CITY OF SAINT PAUL
Melvin Carter, Mayor

DATE: July 22, 2020
TO: Saint Paul Planning Commission
FROM: Comprehensive and Neighborhood Planning Committee
SUBJECT: Districts 14 and 15 Residential Design Standards Amendments – Final Recommendation

Draft Language for Districts 14 & 15 Residential Standards (marked up)

Figure 1 - Example of Potential Expansion under Public Hearing Draft Language (dimensions approximate)

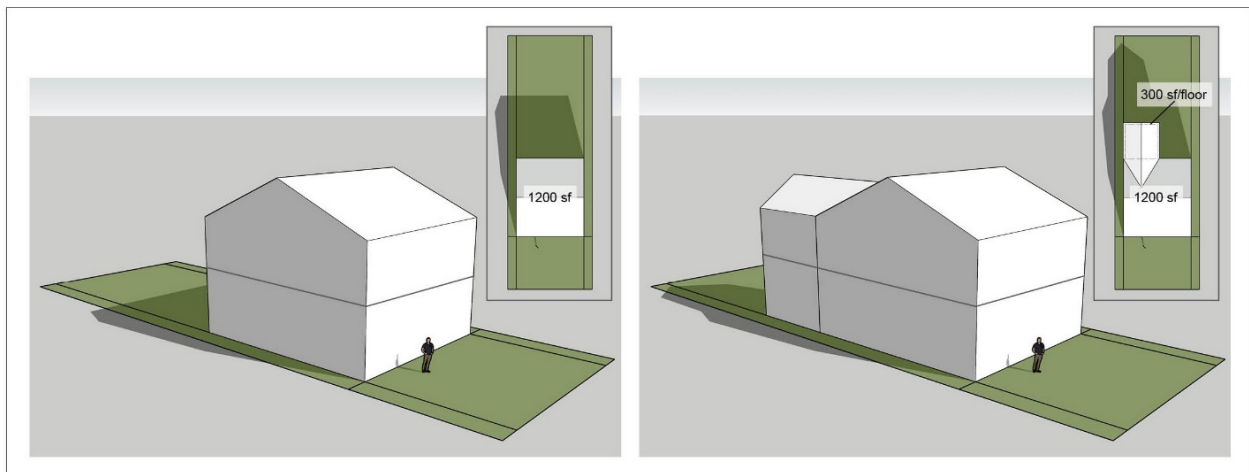
Highland District Council (HDC) expressed concern that the expansion exemption allowing the standard 30' height limit was too lenient and significantly eroded the intent of the standards. The primary issue was that long and tall additions could be built along property lines or within nonconforming setbacks that would fall within the suggested 50% floor area expansion trigger. For example, a house with a 1,200 square foot building footprint could build up to a 600 square foot addition split between two floors and not be subject to reduced height limits. Each of the new floors could be about 17' x 17' if built square and there would be no reduced height limit per the current language. The effect could be the addition of a 17' long addition along the property line with a wall height around 30' (see Figure 1). If the addition was not square and stretched along the property line, the impact would be even greater.

WHEREAS, the Committee suggested dropping the exemption for projects that expand by less than 50% from the height requirement, to prevent additions on a 4 foot side yard setback that could go up to 30 feet; therefore

This suggestion is sensible and addresses one of the goals for this study, which is to maintain the intent of the original standards. For clarity, the proposed language specifies that additions, in addition to new construction, must also meet the reduced height requirement. There remains a proposed 2' increase of allowed height at side setback lines (22' current, 24' proposed) for houses in the R4 zoning district to account for construction challenges related to truss height.
